TRANSPORT TECHNICAL NOTE

PL/AH/35849

Steyning Grammar School, Shooting Field, Steyning, West Sussex

Response to West Sussex County Council Highways, Active Travel England (ATE) and Steyning Parish Council.

FIGURE 1: PRINCIPAL PEDESTRIAN AND CYCLE ROUTE CORRIDORS

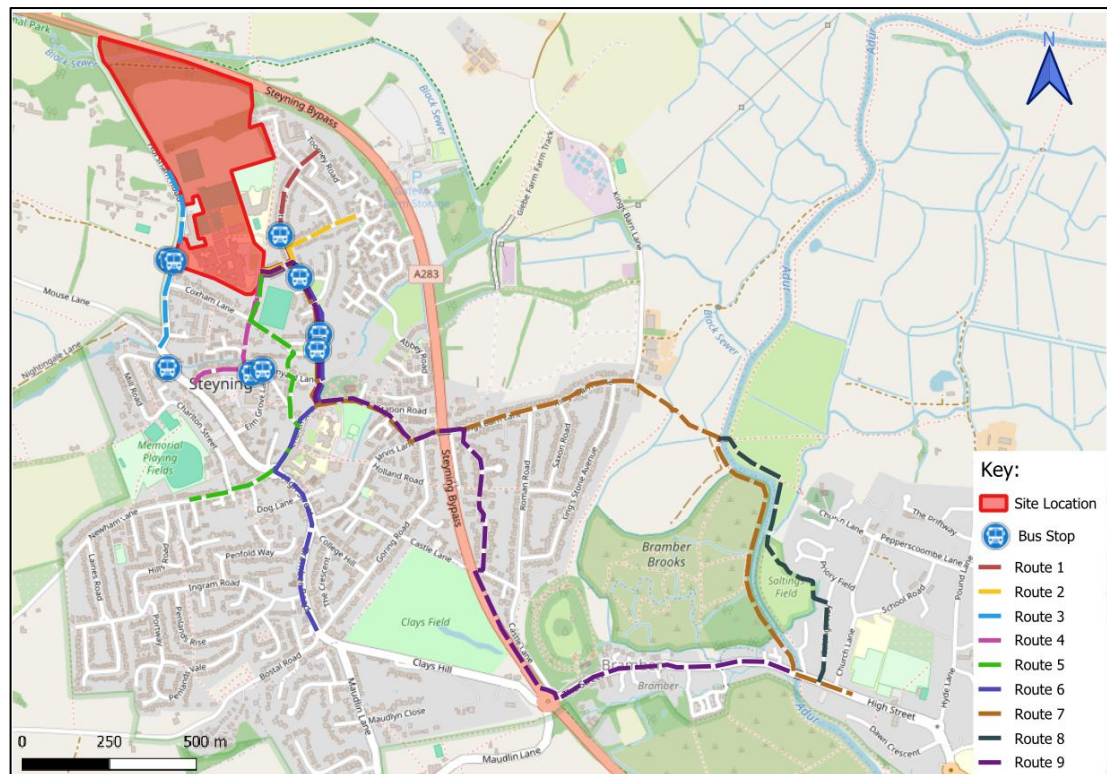
- *Qualitative audit of these routes for walking and cycling, as per the Cycle Level of Service and Walking Route Audit Tool"*
- 1.2.16 As requested by ATE, the mode share and trip attraction data for students has been extended to include the periods 07:00-08:00 and 16:00-17:00 (which are the primary arrival and departure periods), as shown in Table 2 below. Please note that this data accounts for a daily student absence rate of 5 per cent, in line with the assumptions set out within the submitted TA.

- 1.2.19 A review of the student mode share and home postcode data included at **Appendix D** has been completed and it is evident that the routes highlighted in Figure 1 below are the principal walking and cycling routes that students will utilise to access the school. This reflects considerations including distance, comfort/safety and gradient. Please note that the red lines denote walking routes and the green lines denote cycle routes.

- 1.2.20 It was agreed with ATE that these routes would form the basis of the requested walking and cycling audits, which were subsequently completed on Friday 22nd May 2026 and is submitted alongside this Transport Technical Note.
- 1.2.21 The audits identified a number of potential enhancements to local pedestrian and cycle infrastructure, which will be drawn to the attention of WSCC, as the Highway Authority responsible for the management and maintenance of this infrastructure.
- 1.2.22 The requested Framework Travel Plan has also been prepared, in liaison with the school and will be submitted alongside this TTN.

Problems Location Plans

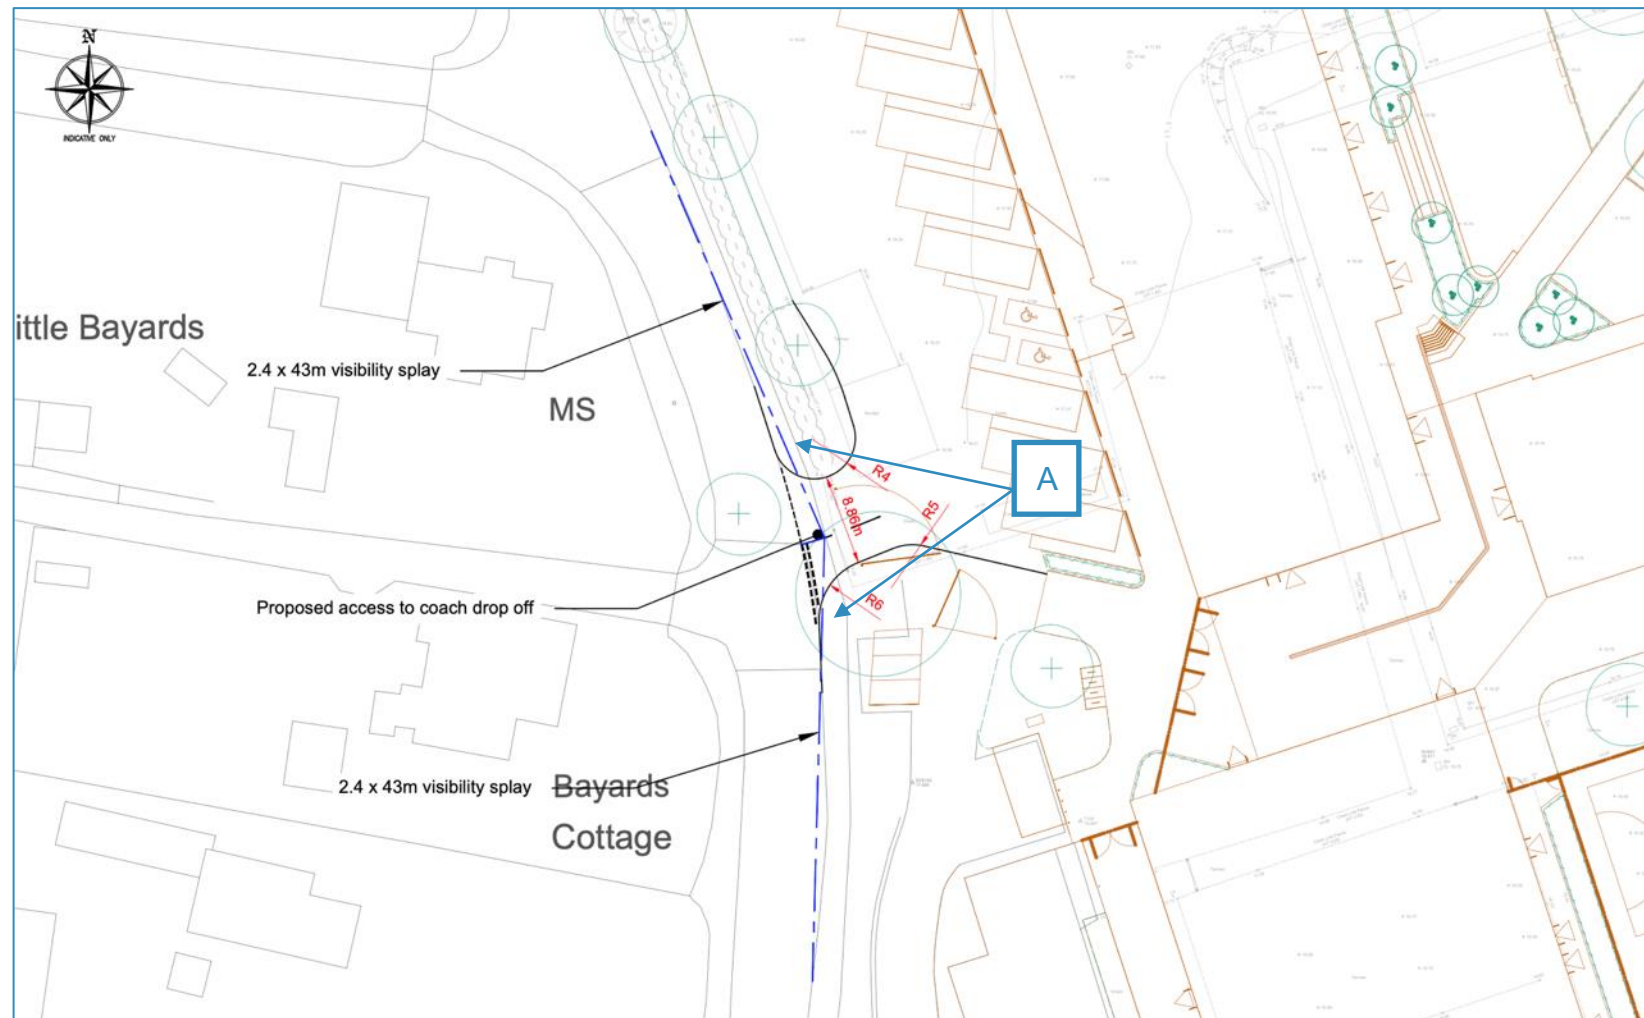
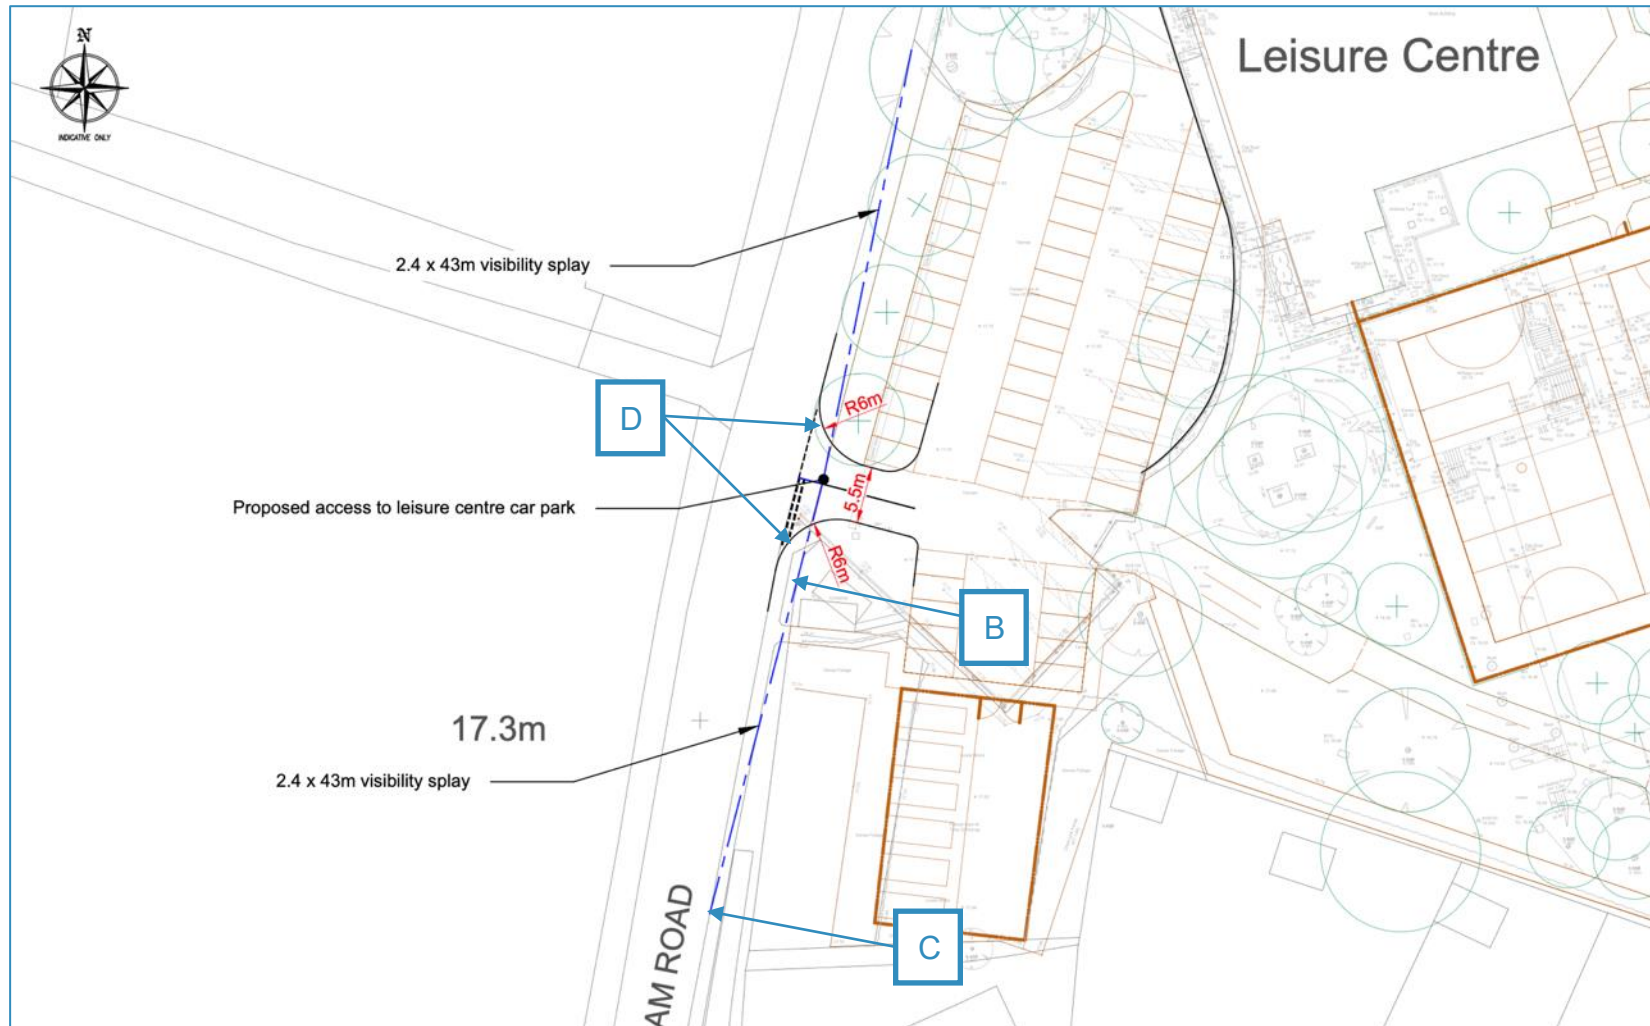
Location: A – Each side of the Northern Access (Dwg. 35848-H-01 Rev. P3).

The drawing shows visibility splays but does not state that vegetation will be trimmed back to achieve the required visibility in each direction. If visibility is obstructed the risk of side impact collisions increases. Photos 1 and 2 show that the hedgerow to the north and low tree branches to the south currently obstruct visibility onto Horsham Road.

Location: B – Southern side of the Southern Access (Dwg. 35848-H-02 Rev. P3).

The drawing shows visibility splays but does not state that vegetation will be trimmed back to the south to achieve the required visibility. If visibility is obstructed the risk of side impact collisions increases. Low tree branches to the south currently obstruct visibility onto Horsham Road.

Location: C – Southern approach to the Southern Access (Dwg. 35848-H-02 Rev. P3).

The auditors observed northbound speeds, approaching the southern access, that were in excess of the 30mph speed limit. The 'y' distance provided is appropriate for a 30mph speed limit, but higher mean speeds are likely to require a longer 'y' distance if the risk of side impact collision is to remain suitably low.

Location: D – Southern Access (Dwg. 35848-H-02 Rev. P3).

No uncontrolled pedestrian crossing has been provided across the mouth of the access junction, increasing the risk of pedestrian trips and falls.

The hedgerow to the north of the northern access, and the trees to the south should be cut back hard and maintained as such thereafter.

The low tree branches to the south should be removed and maintained as such thereafter.

Northbound approach speeds should be measured and the 'y' distance for the southwards visibility should be calculated and implemented accordingly.

An uncontrolled pedestrian crossing, with dropped kerbs and tactile paving, should be provided across the mouth of the southern access junction

Item	RSA Issue	RSA Recommendation	Design Organisation Response	Overseeing Organisation Response	Agreed RSA Action
2.1	Location: A – Each side of the Northern Access (Dwg. 35848-H-01 Rev. P3). Summary: Risk of side impact collisions if visibility is obstructed. The drawing shows visibility splays but does not state that vegetation will be trimmed back to achieve the required visibility in each direction. If visibility is obstructed the risk of side impact collisions increases. Photos 1 and 2 show that the hedgerow to the north and low tree branches to the south currently obstruct visibility onto Horsham Road.	The hedgerow to the north of the northern access, and the trees to the south should be cut back hard and maintained as such thereafter.	Agreed. The vegetation will be cut back and maintained to ensure that the proposed visibility splays are achievable. This has been stated on revised drawing H-01 Rev. P5.

2.2	Location: B – Southern side of the Southern Access (Dwg. 35848-H-02 Rev. P3). Summary: Risk of side impact collisions if visibility is obstructed. The drawing shows visibility splays but does not state that vegetation will be trimmed back to the south to achieve the required visibility. If visibility is obstructed the risk of side impact collisions increases. Low	The low tree branches to the south should be removed and maintained as such thereafter.	Agreed. As set out in the response to 2.1, vegetation within the proposed visibility splays will be cut back to ensure clear visibility; this is shown on revised drawing H-02 Rev. P4.

2.3	Location: C – Southern approach to the Southern Access (Dwg. 35848-H 02 Rev. P3). Summary: Risk of side impact collisions if inadequate visibility is provided. The auditors observed northbound speeds, approaching the southern access, that were in excess of the 30mph speed limit. The 'y' distance provided is appropriate for a 30mph speed limit, but higher mean speeds are likely to require a longer 'y' distance if the risk of side impact collision is to remain suitably low.	Northbound approach speeds should be measured and the 'y' distance for the southwards visibility should be calculated and implemented accordingly.	Noted. The existing southern access is being formalised as part of the development proposals to the existing speed limit of 30mph. Increased visibility splays beyond what is required could, in turn, encourage higher vehicle speeds. Vehicles approaching from the south of the access are travelling in the non-critical direction, with double white lines instead of a standard centreline, prohibiting overtaking. By extending the 2.4 x 43m visibility splays to the centreline, 81m of visibility would be achieved, equating to an approximate design speed of 40mph in accordance with MfS2 guidance.

Item	RSA Issue	RSA Recommendation	Design Organisation Response	Overseeing Organisation Response	Agreed RSA Action
	kerbs when crossing the mouth of the access junction. No uncontrolled pedestrian crossing has been provided across the mouth of the access junction, increasing the risk of pedestrian trips and falls.		paving will be incorporated at this location, as shown on revised drawing H-02 Rev. P4.
